FOOD LION, INC.
PROPOSED FOOD LION STORE
RIDGE ROAD (FM 740) @ FM 3097
ROCKWELL, TEXAS

REVIEW OF THE SITE PLAN FOR FOOD LION STORE

RE: Food Lion Site Plan

Agenda Item: P&Z 09-23/SP/PP - Discuss and Consider Approval of a Site Plan/
Preliminary Plat/Building Plan for Food Lion Grocery Store

LANDSCAPE PLAN DATA SHALL MEET ORDINANCE NO. 88-23

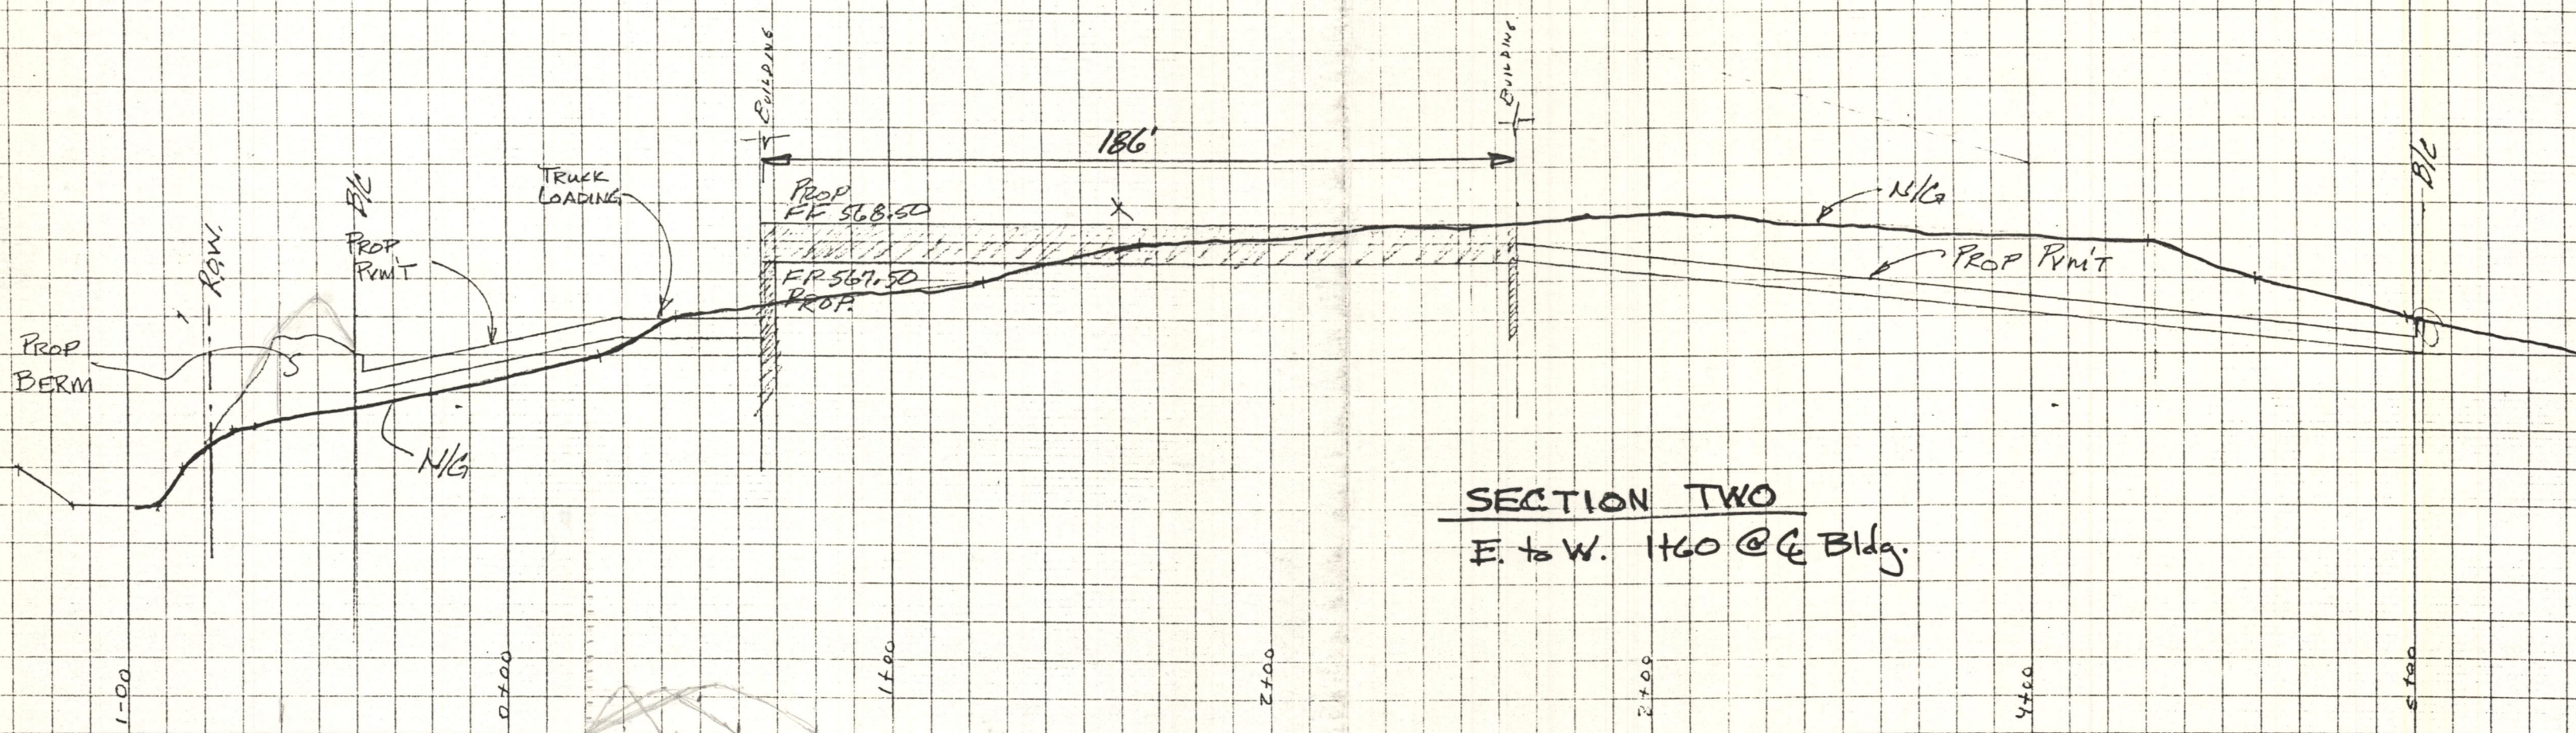
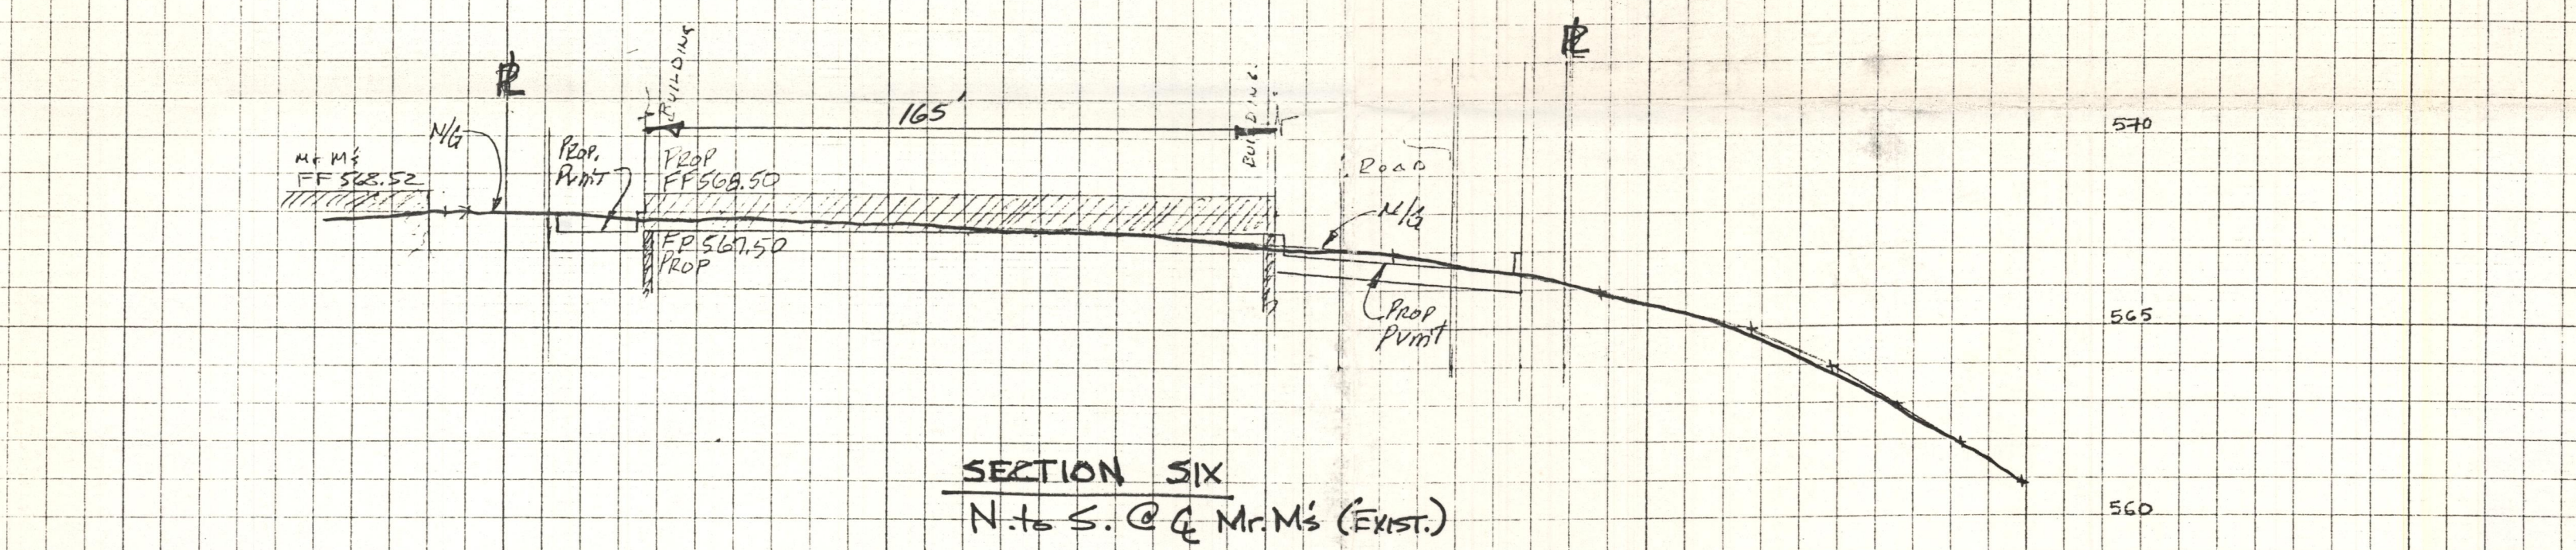
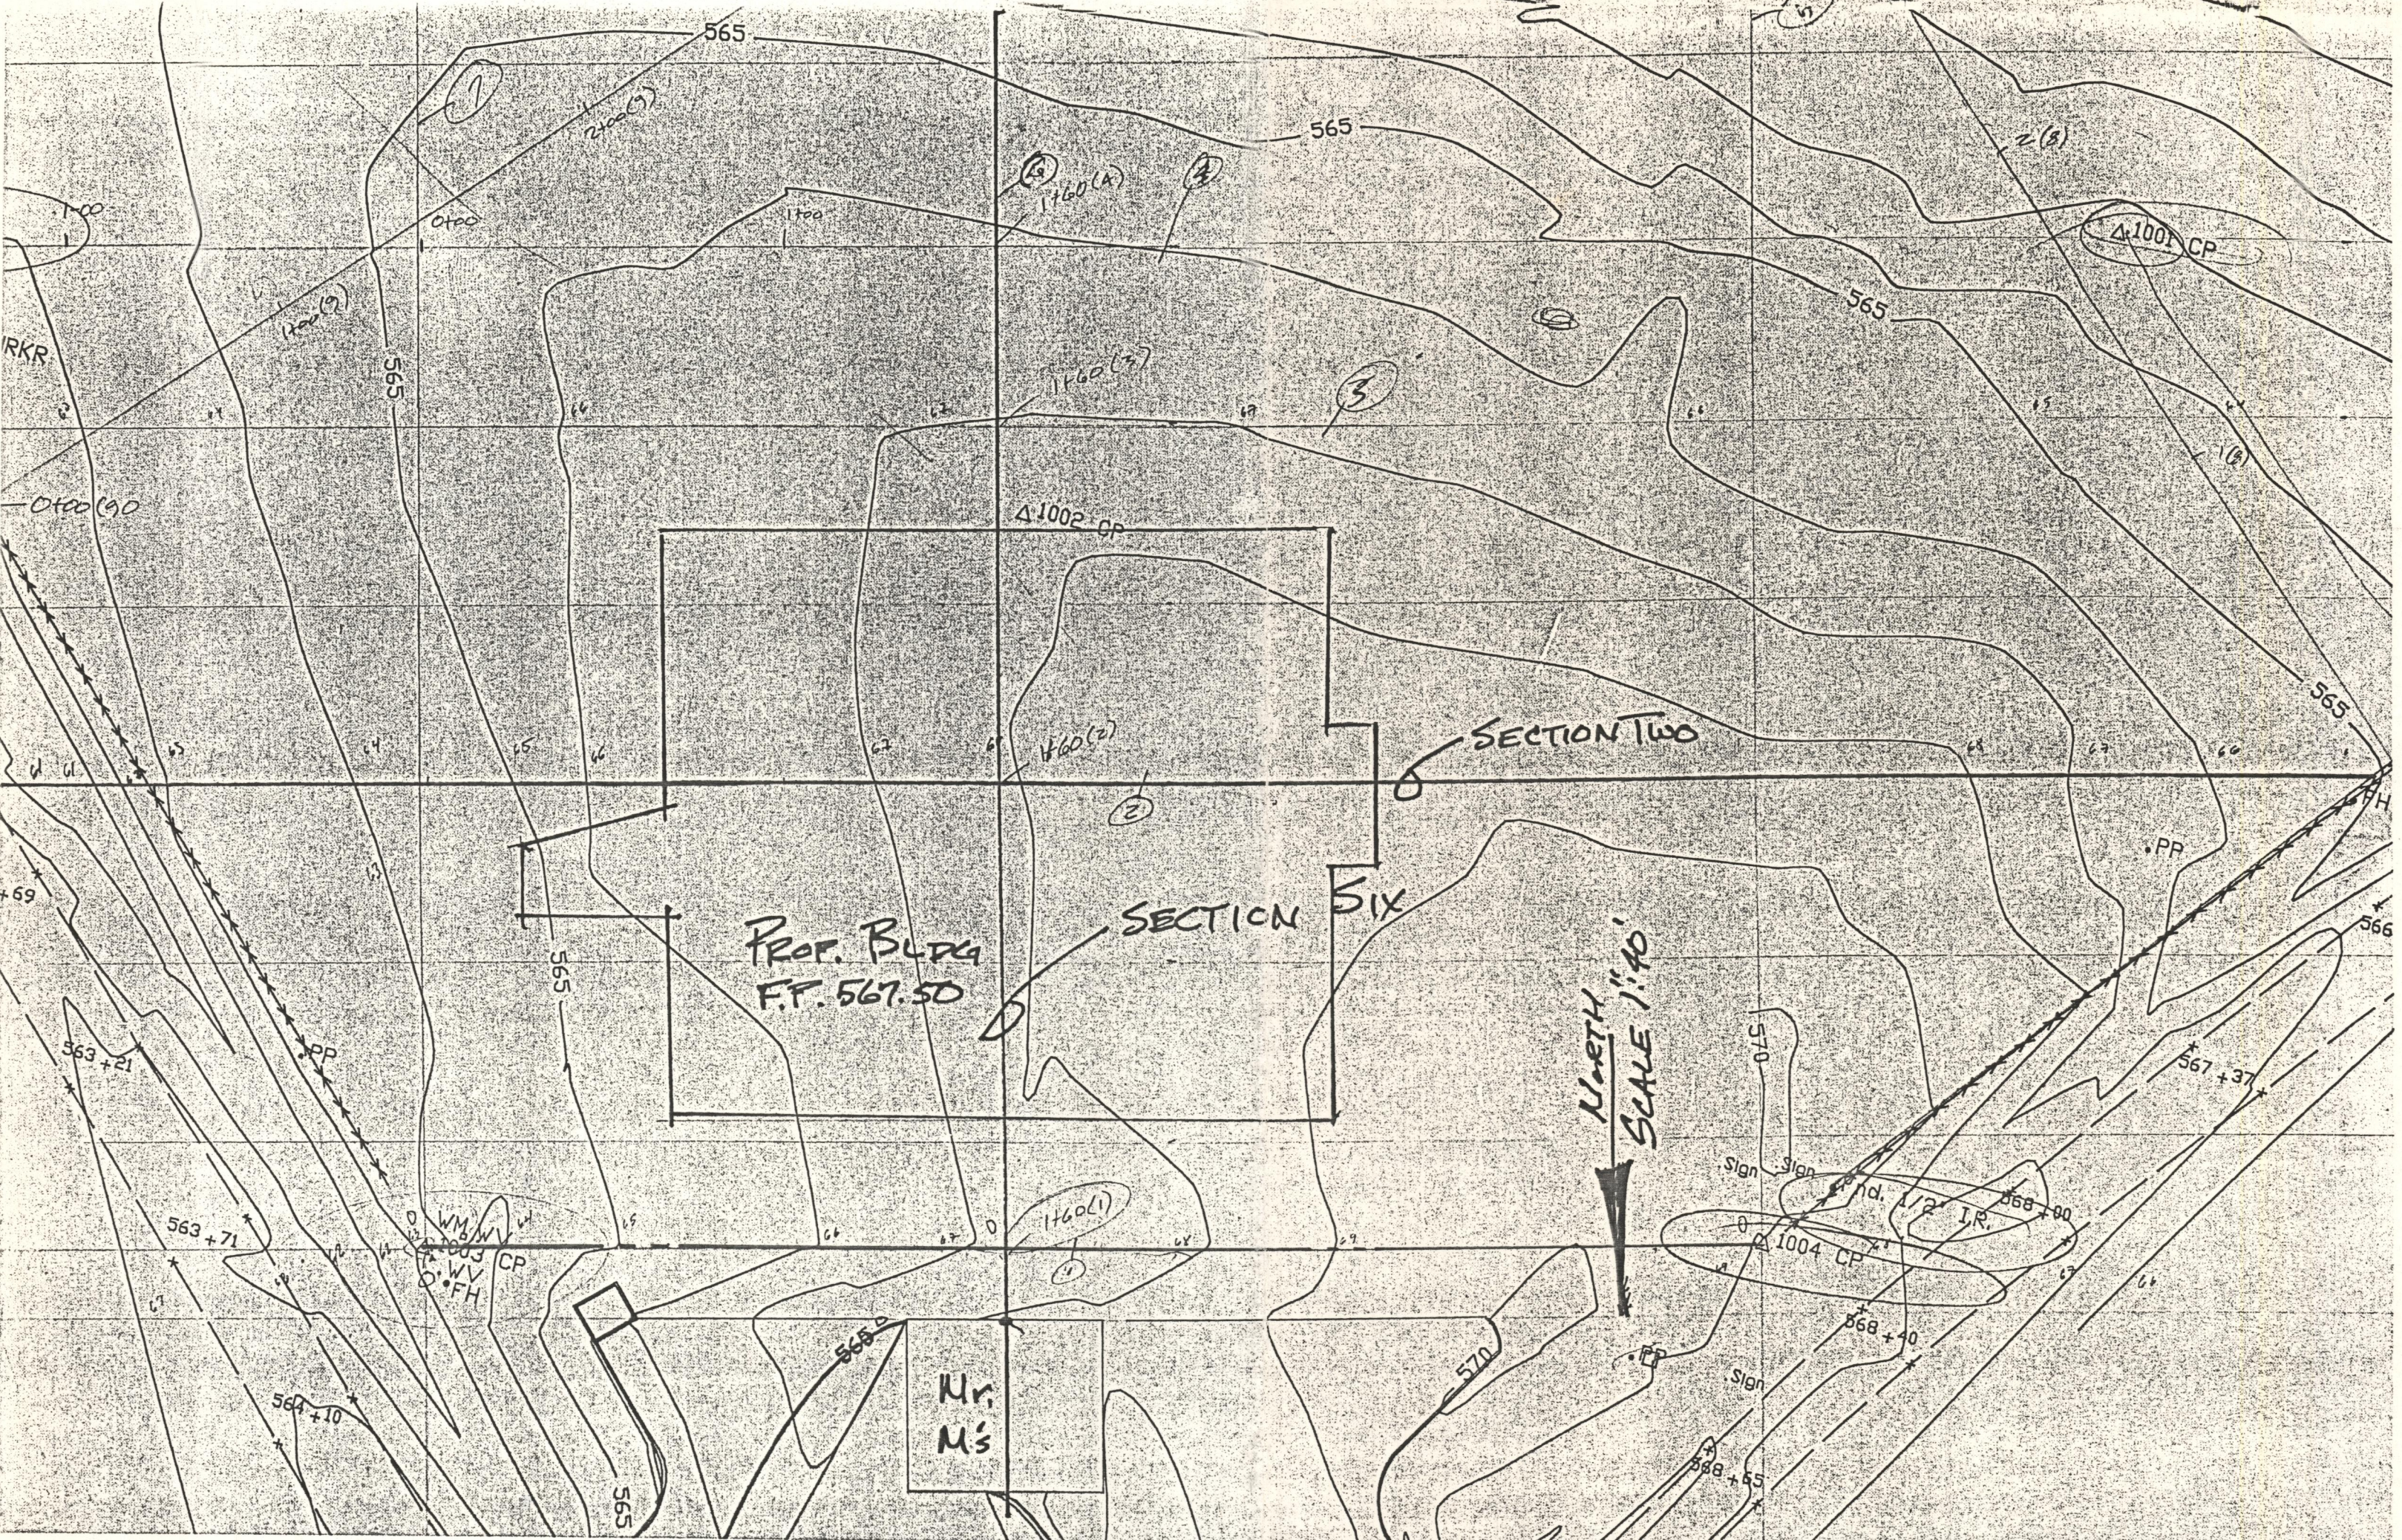
12,240 must be in front

have 21,942 and the new dedication checker need

find 1163 interior to parking lot need 2502 interior to parking lot would add 500 to outside the - shown

1. The applicant is providing 12.5% of landscaping with a credit of 2.5% for the 3' berm on FM-740 and FM-3097. They need to adjust the landscaping in the interior of the parking lot to provide 5% in landscaping. They are currently only providing approximately 2.5%.
2. They need to provide additional trees along the street frontages. They are required to have trees equal to 1 per 30 feet in the OV district and they are only providing 1 per 50 feet. They are requesting approval to not use that many trees in the front because it blocks the view of the building from the street.
